Product/process change notification

PCN N° 2021-103-A

Introduction of new lead frame and lead finish material for dedicated products in TO247 package with assembly site Tijuana, Mexico

Lead Frame Design

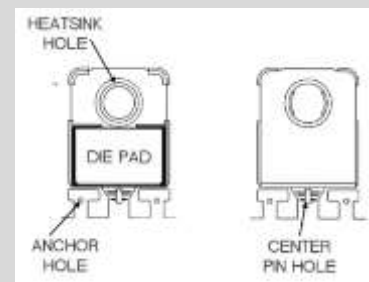
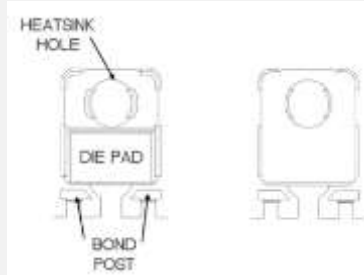
Subject Change of Lead Frame and Lead Finish material

Reason Standardization of assembly and lead finishing process

Lead Finish Material

Lead Finishing Process

Old

- 99.3% Sn / 0.7% Cu
- Solder Dip leads

New

- 100% Sn
- Electroplated on the heatsink and leads
